DECISION, CONDITIONS, FINDINGS OF FACT, AND CONCLUSIONARY FINDINGS OF THE MCMINNVILLE HISTORIC LANDMARKS COMMITTEE FOR APPROVAL OF THE ALTERATION OF A HISTORIC BUILDING AT 711 NE 3RD STREET WITHIN THE DOWNTOWN DESIGN AREA

- DOCKET:** DDR 4-18
- REQUEST:** The applicant has submitted a Downtown Design Review application to request the alteration of a historic building in the Downtown Historic District, which is listed on the National Register of Historic Place.

- LOCATION:** The subject site is located 711 NE 3rd Street, and is more specifically described as Tax Lot 5200, Section 21BD, T. 4 S., R. 4 W., W.M.
- ZONING:** The subject site is designated as Commercial on the McMinnville Comprehensive Plan Map, and is zoned C-3 (General Commercial).

The proposed design for the reconstructed storefront window systems and entries can be seen below:

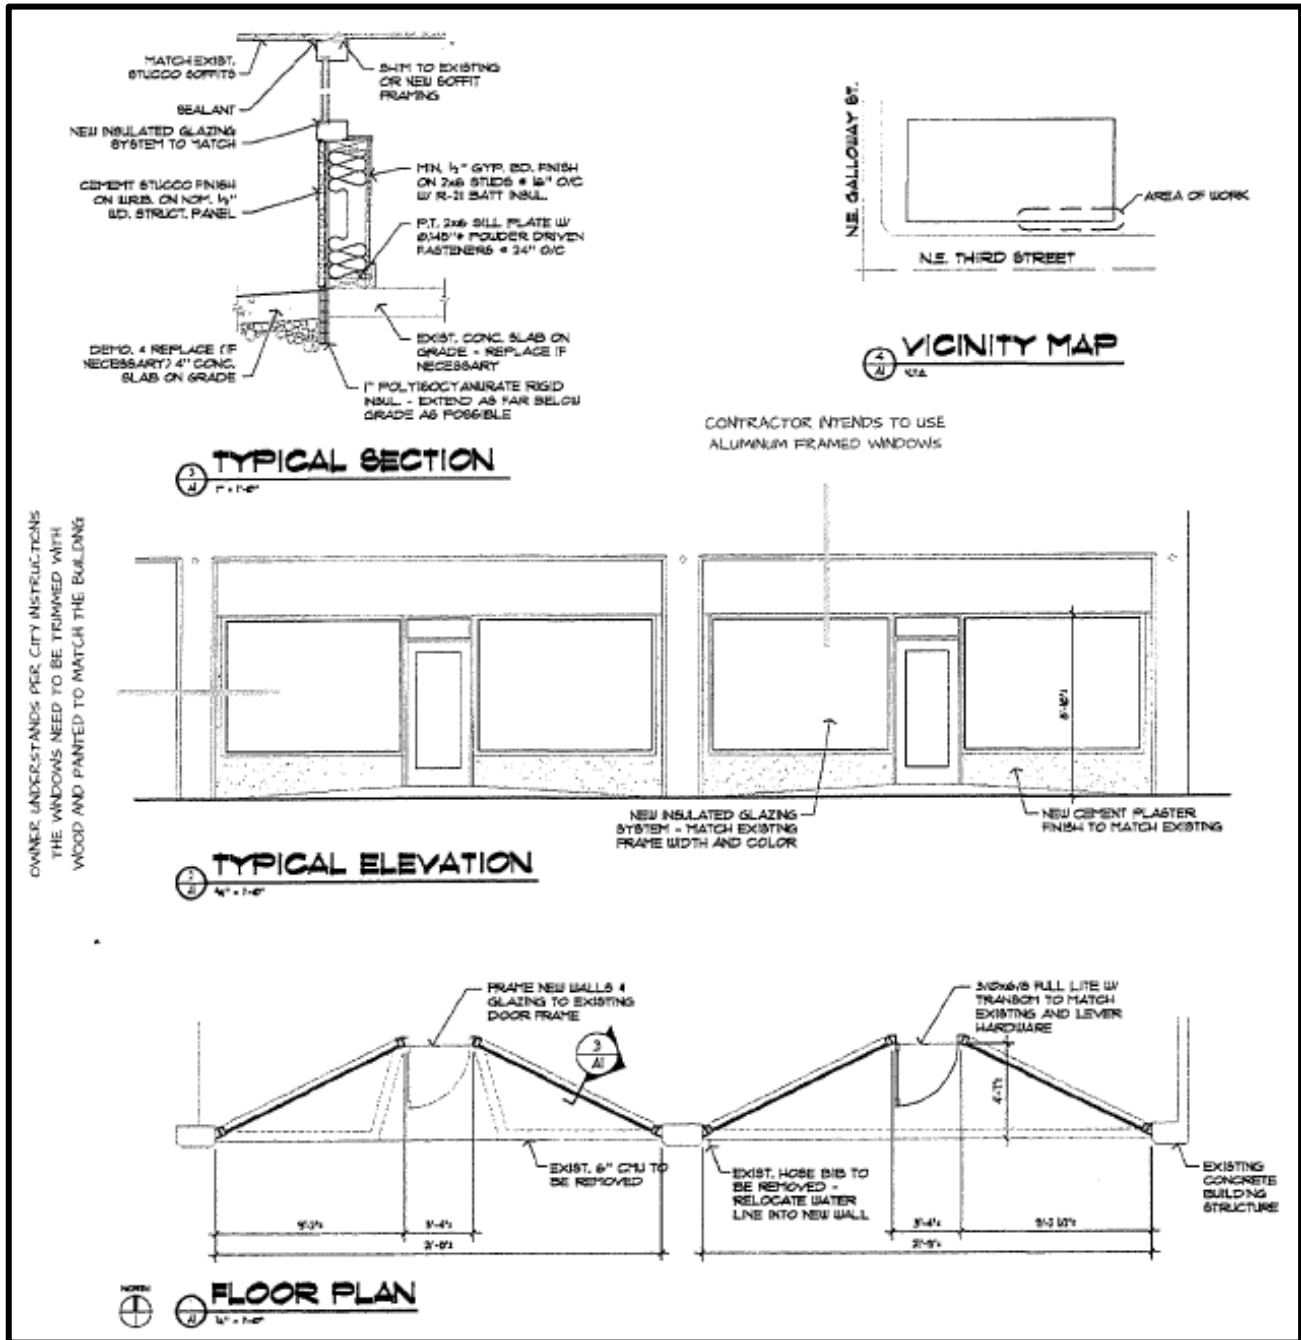
Additionally, the design has inadequate maneuvering clearance for ADA on the latch side of the doors.

The glazing that will go adjacent to the doors will need to be safety glazing as well as the glazing within the doors.

Door hardware must be ADA compliant (e.g., lever-type).

The threshold height is not indicated but must be held to a maximum of ½ inch for ADA.

1. That the storefront windows be wood framed windows, or that wood trim and sills be applied to the exterior of the internal aluminum framed windows.
2. That the applicant shall submit building permit applications prior to completing any work, and that the construction plans submitted with the building permit applications shall be consistent with the exhibits, drawings, and renderings submitted for review by the Historic Landmarks Committee, and consistent with all applicable conditions of approval.
3. Any future signage proposal shall be submitted to the Planning Department for review and approval by the Planning Director or Historic Landmarks Committee, depending on whether the signage constitutes a major or minor alteration to the site, prior to installation. It shall be the Planning Director's decision as to whether the signage proposed is a major or minor alteration.

The windows are proposed to be recessed by from the outer wall and above the bulkhead beneath the windows. The recessed windows are shown in the section below:

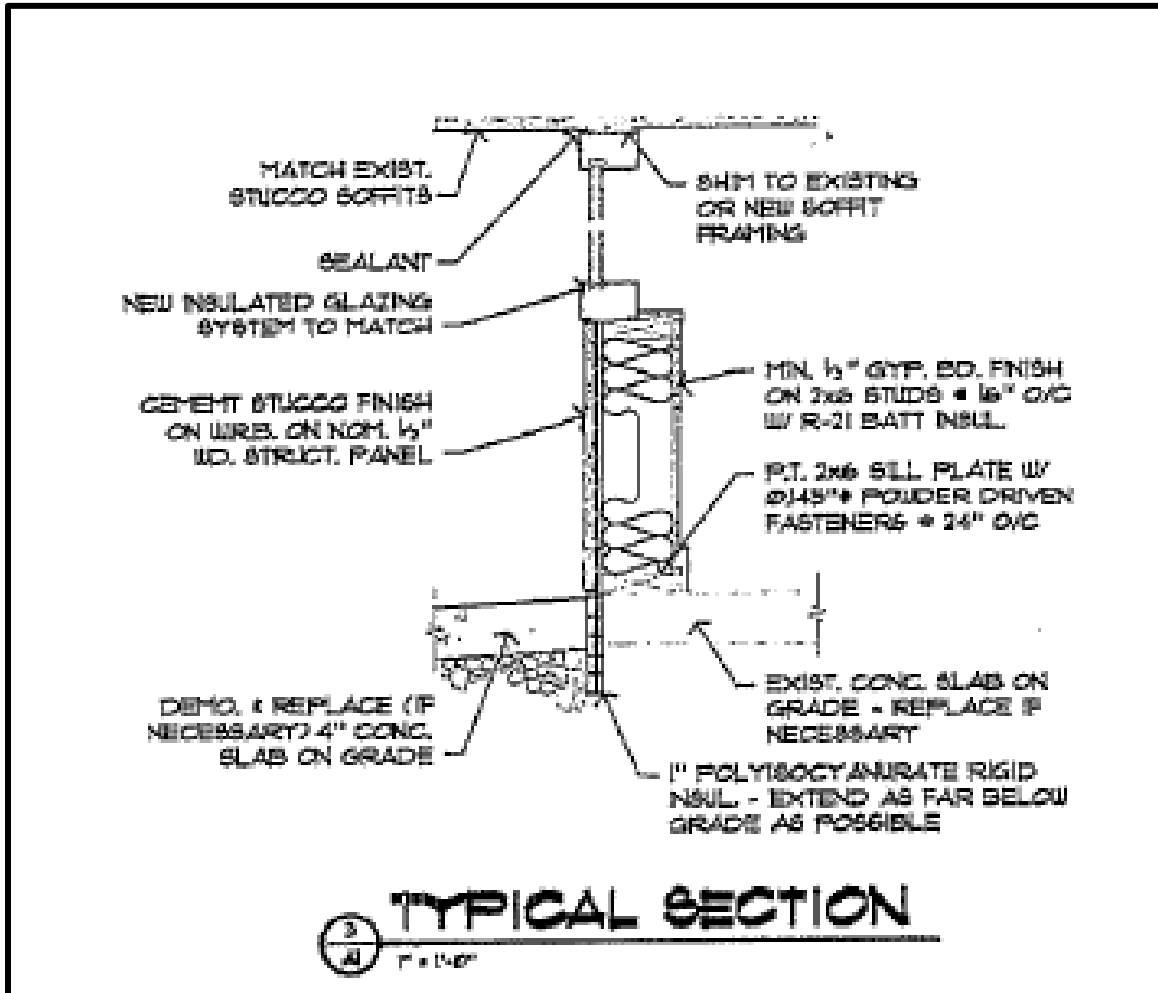
The proposed design includes the use of stucco on the portions of the new façade that will not be glazing. The windows are proposed to be aluminum framed windows and steel doors. Metal (such as aluminum and steel) is not listed as an allowable exterior building material. A condition of approval is included to require that the storefront windows be wood framed windows, or that wood trim and sills be applied to the exterior of the internal aluminum framed windows. The wood material is one that is specifically listed as an allowable exterior building material.
